In re: K215BA Translator, Beaumont, CA
Santa Monica Community College District
Family Life Ministries, Inc.
BPFT-20010305ABU
Facility ID: 59090

This refers to the above-captioned application for minor modification to the licensed facility of Translator K215BA, Beaumont, CA.

LAMBERT EQUAL AREA MAP

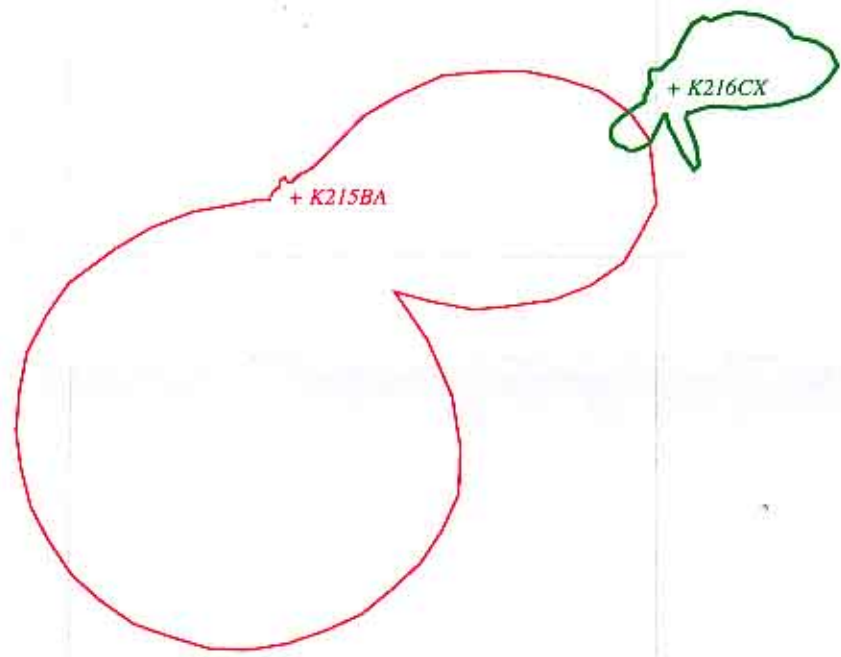
Our engineering study of the application reveals that it is in violation of 47 C.F.R. § 74.1204(a) with respect to the first-adjacent licensed facility of K216CX, Yucca Valley, CA, (BLFT-19950426TG). Section 74.1204(a) states that an application for an FM translator station will not be accepted if the proposed operation would involve prohibited overlap of predicted field strength contours with any other authorized station. The proposed 54 dBu interference contour overlaps the protected 60 dBu contour of K216CX, (see attachment). The application did not address this violation. Therefore, the application will be dismissed.

In light of the above, Application BPFT-20010305ABU is unacceptable for filing pursuant to 47 C.F.R. § 73.3566(a) and IS HEREBY DISMISSED. This action is taken pursuant to 47 C.F.R. § 0.283.
